AMENDMENTS TO THE DRAWINGS

Patent Application Docket No. 08856-00015USPT

FIG. 4

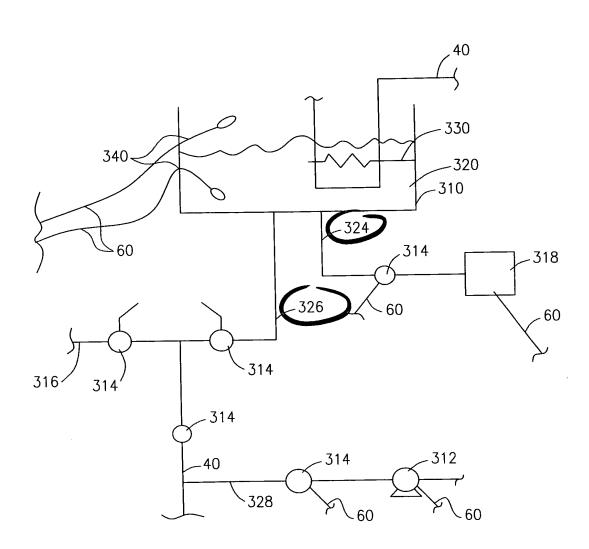
Figure 4 has been amended to include elements 324 and 326 so that they coincide with the specification at page 12, lines 11-20.
